## City of Sumter Design Review Board

## HP-22-13, 210 Church St.

Request: Request for Design Review approval for

construction of a new second floor access stair at

**Above**: rear view of residence prior to alterations approved via HP-19-13 showing previous 1st floor rear access stair configuration and covered  $2^{nd}$  floor addition that has been modified.

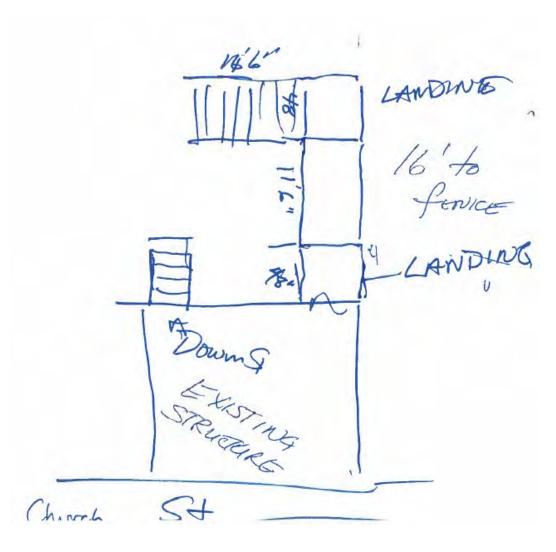
The location of the proposed 2<sup>nd</sup> floor exterior staircase was previously occupied by a 1<sup>st</sup> floor exterior staircase and landing. In addition, prior to renovations completed under *HP-19-13*, an internal 2<sup>nd</sup> floor access stair was located inside the 2-story addition. Due to structural deficiencies identified in the addition, the renovations under *HP-19-13* included removal of that access staircase and conversion of the addition to open porch space. While the residence contains at least 1 internal access staircase to the 2<sup>nd</sup> floor, the floor plan of the residence and need for emergency egress does warrant construction of a 2<sup>nd</sup> floor access stair.

# Proposed 2<sup>nd</sup> Floor Access Stair Configuration and details (submitted by applicant)

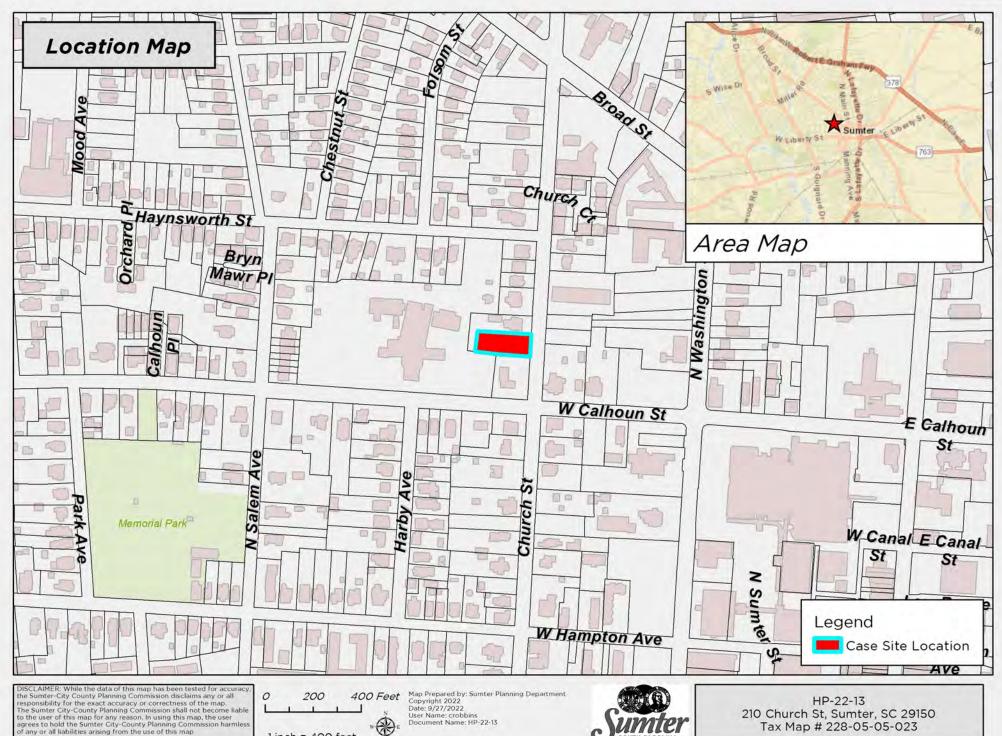
Though construction of the 2<sup>nd</sup> floor access stair is warranted, the proposed materials do not match the existing structure, and no attempt has been made via the proposed designs and course of action submitted to integrate the exterior access stair into the residence as a whole. As a result, the proposed design is generally inconsistent with the Design Guidelines.

While construction of a 2<sup>nd</sup> floor access stair is a valid improvement for the residence, the proposed changes are inconsistent with the City of Sumter Historic Preservation Design Guidelines and are incompatible with the existing building design. An alternative design that is integrated with the building would be more consistent with the intent of the Design Guidelines.

Staff recommends <u>denial</u> of this request.
